Applicant : Alan Phillips
Serial No. : 10/626,842
Filed : July 23, 2003
Page : 3 of 19

Attorney Docket No. P-JK-01496

Amendments to the Drawings

Title: Router Bit System
Inventor(s) Alan Phillips
Serial No.: 10/626,842
Filing Date: July 23, 2003

FIG. 2

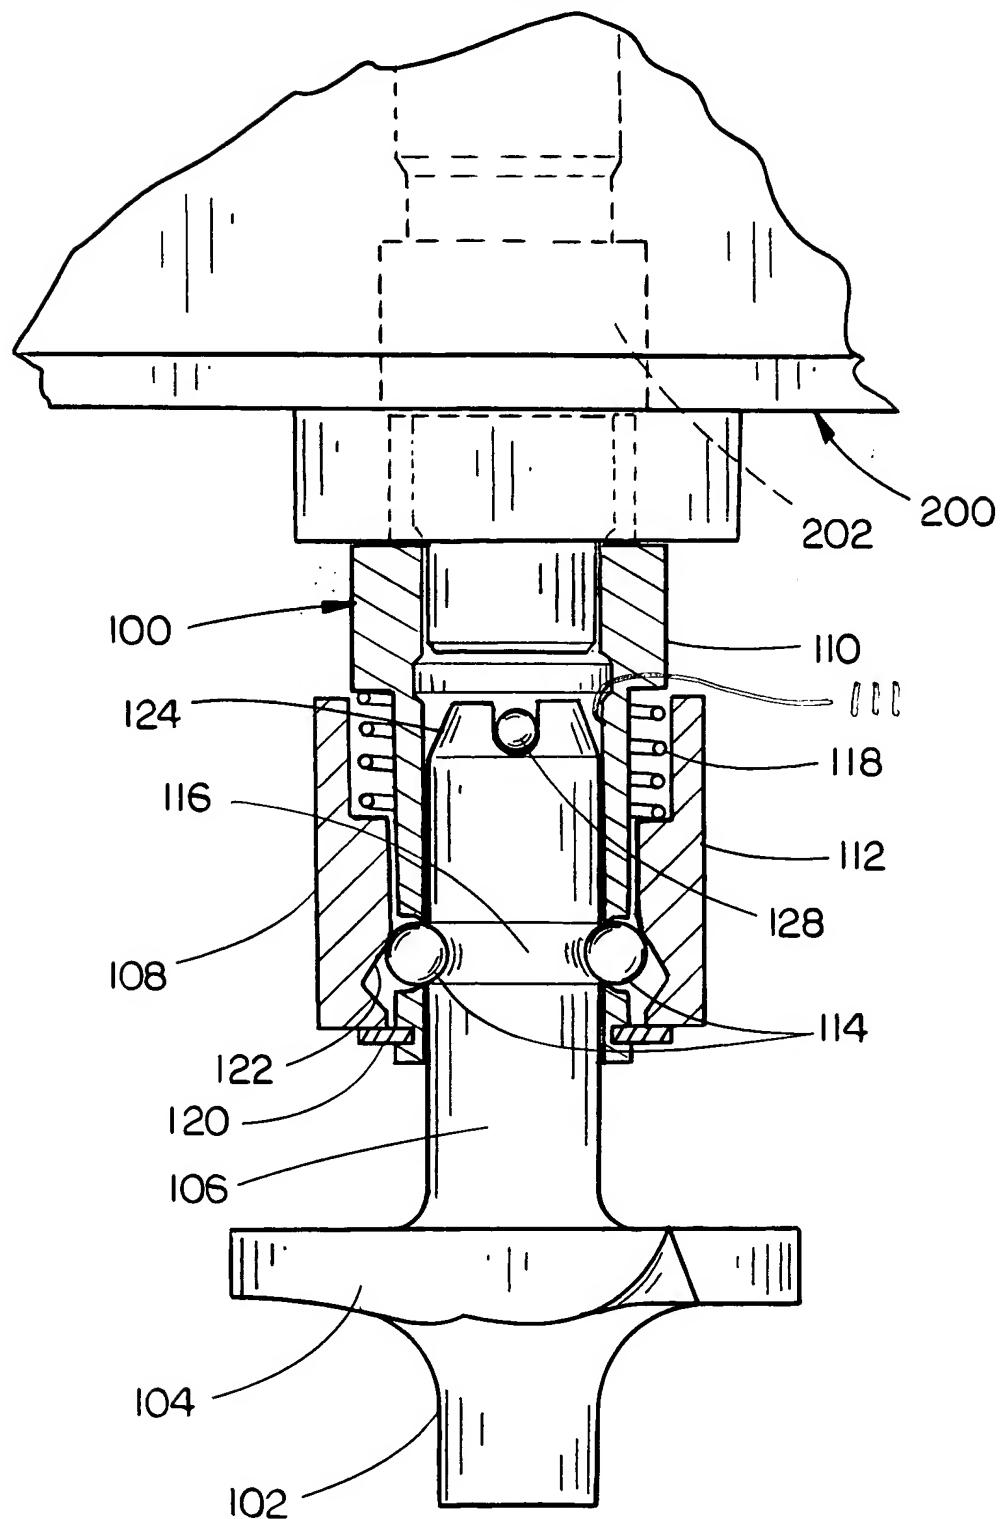
The drawings have been objected to for failure to show the claimed “bore.” Applicants respectfully point out that the drawings and specification, as filed, show and describe a bore in the chuck 110. To clarify, the drawings and specification have been amended to indicate the bore by reference numeral 111. No new matter has been added.

The Office Action also states that it is not clear “what Applicant considers the ‘bore.’” As explained above in response to the drawing objection, the drawings and specification show and describe the bore 111 in the chuck 110.

Please replace sheet 2 of the drawings with the attached replacement sheet. Attached are a version with a redline markup to show changes and a clean copy. Fig. 2 has been amended to add reference numeral 111 that refers to the bore in the chuck 110. No new matter has been added.
